PROPOSED BOUNDARY WALL DESIGN

PROPOSED ALTERATIONS TO NO. 86 SOUTHWOOD LANE

NO.	REV.	D.	AA
SEC-11P11		C.	AA
		DATE.	04/03/25

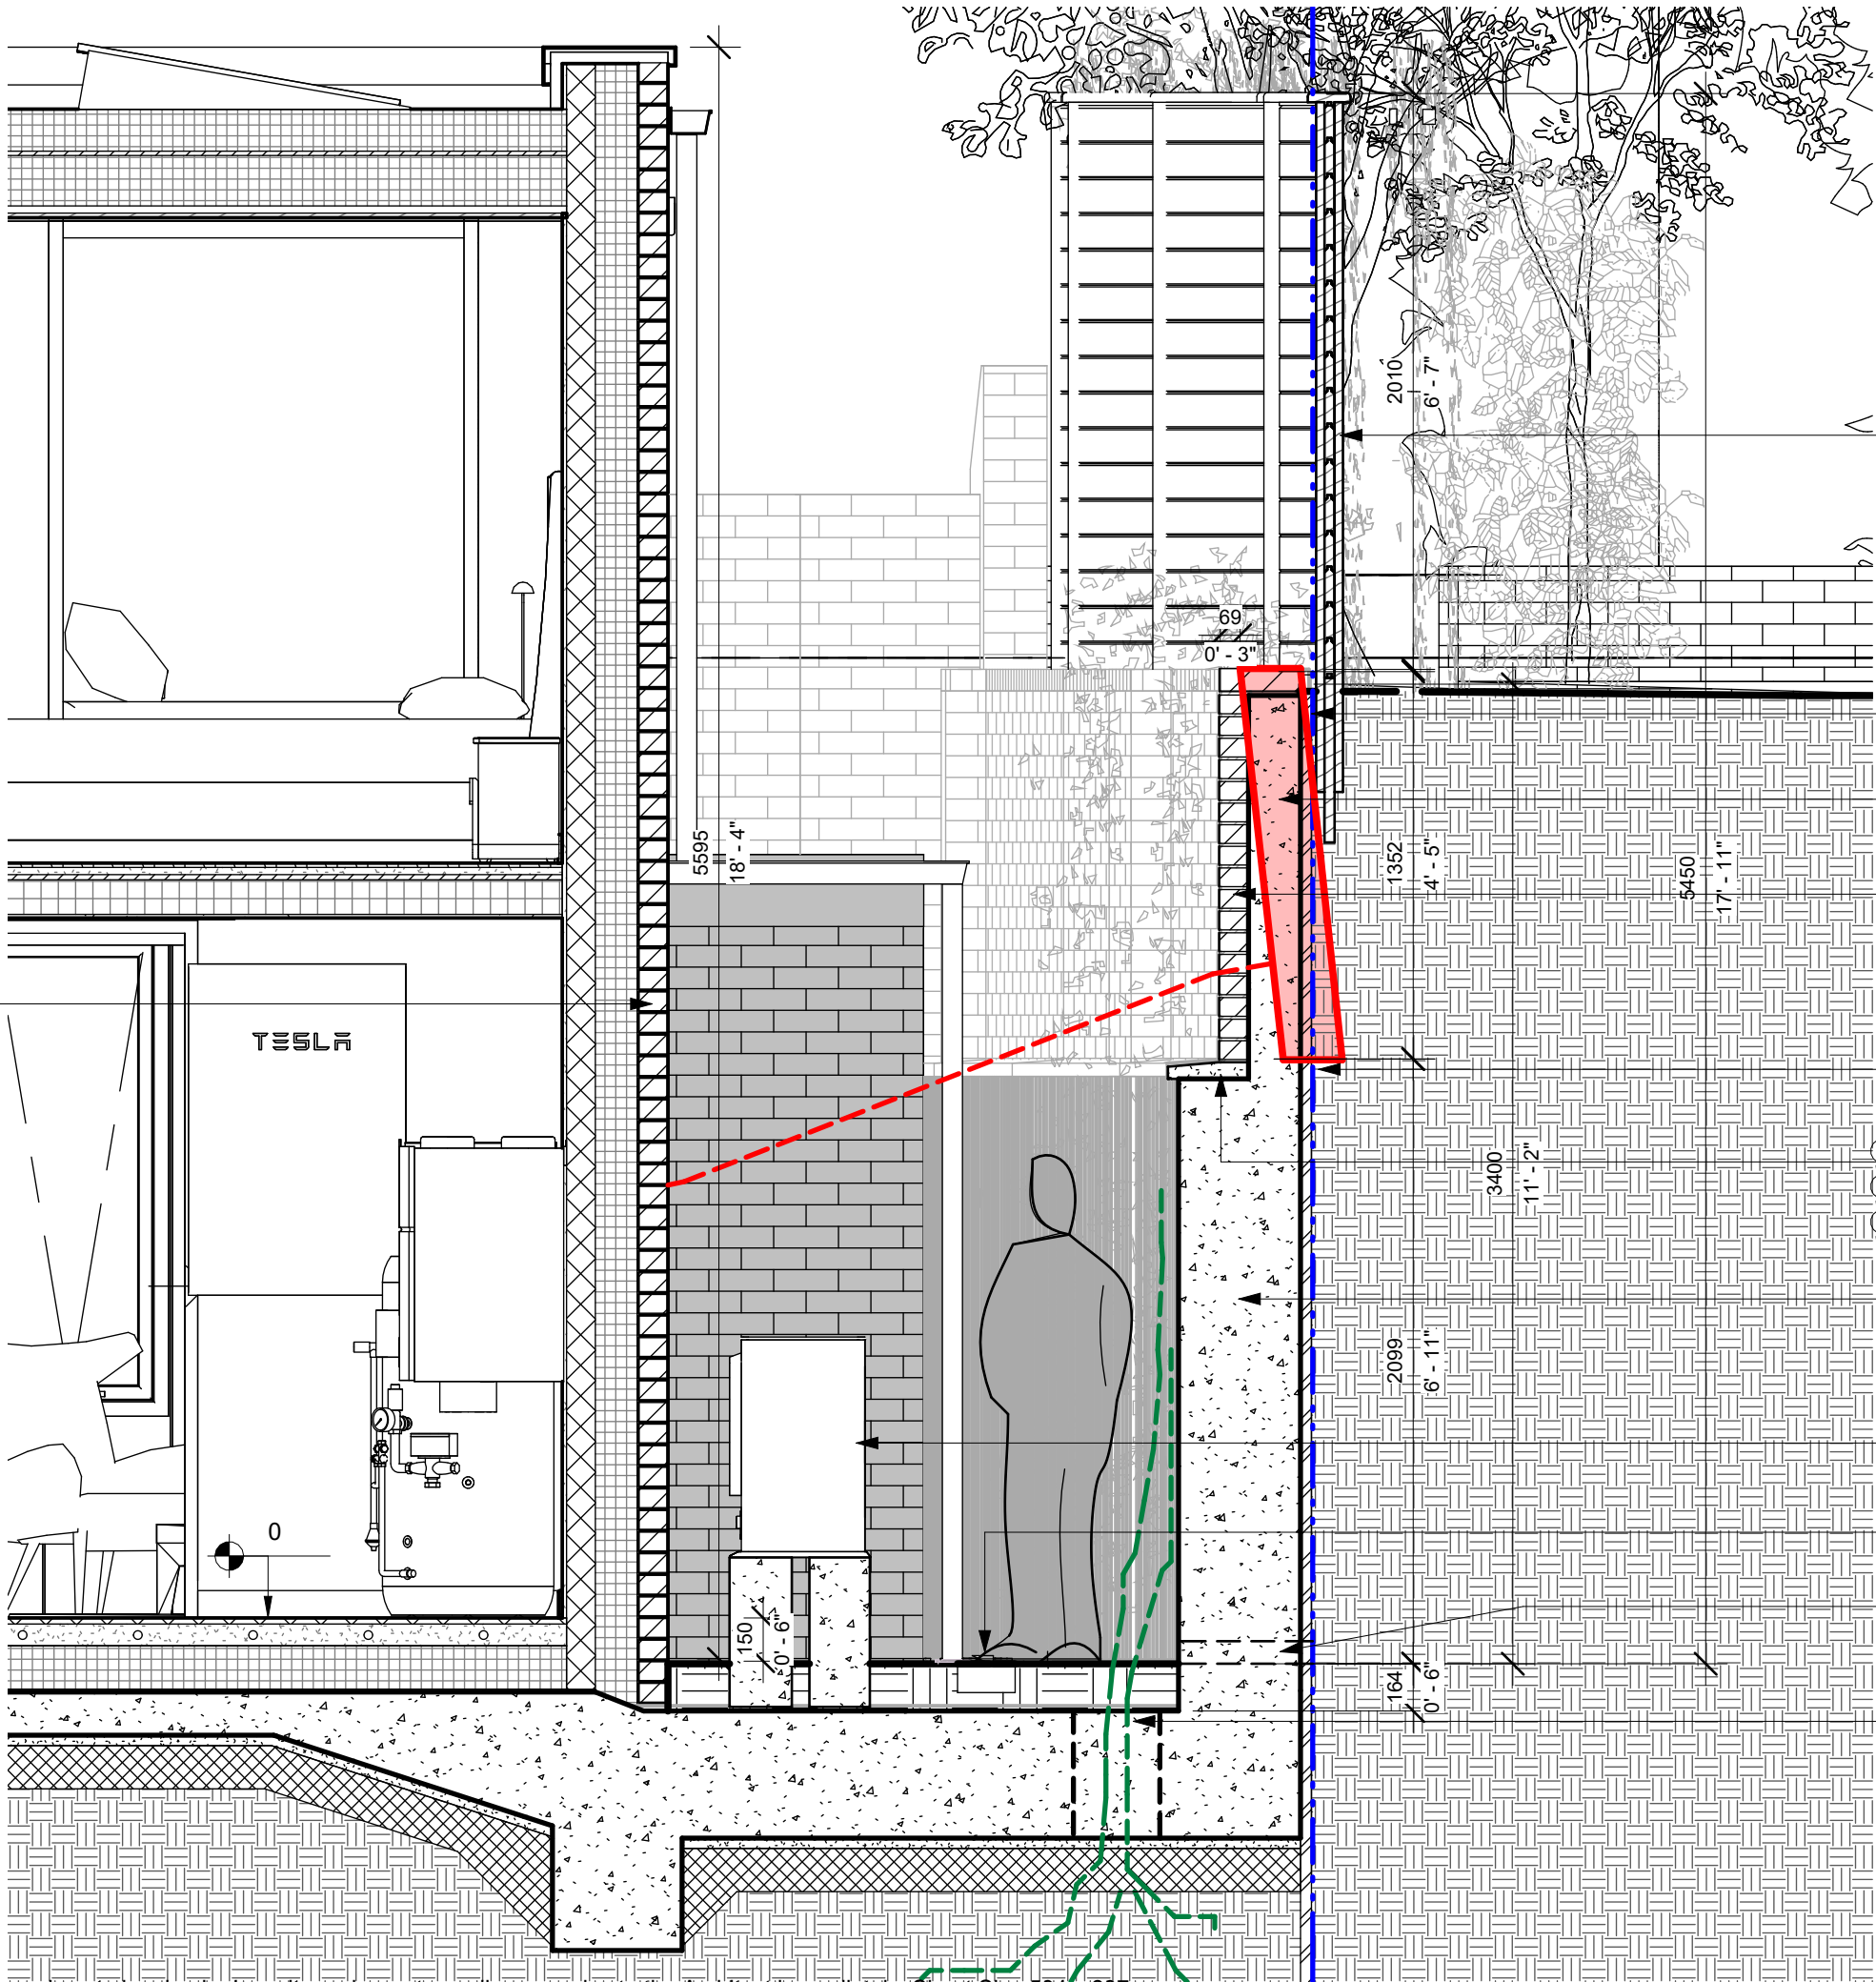
05/12/25 Rev P6 Issued for Planning Permission
- Boundary wall & Timber fence amended

18/12/25 Rev P7 Issued for Planning Permission
- Boundary wall amended following further comments from Haringey Council

26/6/26 Rev P9 Issued for Non-Material Amendment (S.96A)
- Concrete finish annotation amended to Reckli 'Friesland' formliner; all else as approved (HGY/2025/2929)

7/7/26 Rev P10 Issued for Removal or Variation of a Condition (S.73).
Coping stone amended to sandy-toned bullnose. Wall otherwise as approved under HGY/2025/2929 (as amended by HGY/2026/1807).

27/8/26 Rev P11 Issued for Removal or Variation of a Condition (S.73).
Coping amended to brick to match the rebuilt wall following further comments from Haringey Council. Wall otherwise as approved under HGY/2025/2929 (as amended by HGY/2026/1807).

BRICK COPING MATCHING THE REBUILT BRICK WALL AND FINISHING IT AT ITS BASE. PROFILE CUT FROM RECLAIMED BRICKS AS APPROVED UNDER HGY/2026/0905

REINFORCED CONCRETE RETAINING WALL WITH LOWER SECTION HAVING A TEXTURED, BAMBOO/REED-INSPIRED CONCRETE FINISH FORMED USING THE RECKLI 'FRIESLAND' FORMLINER
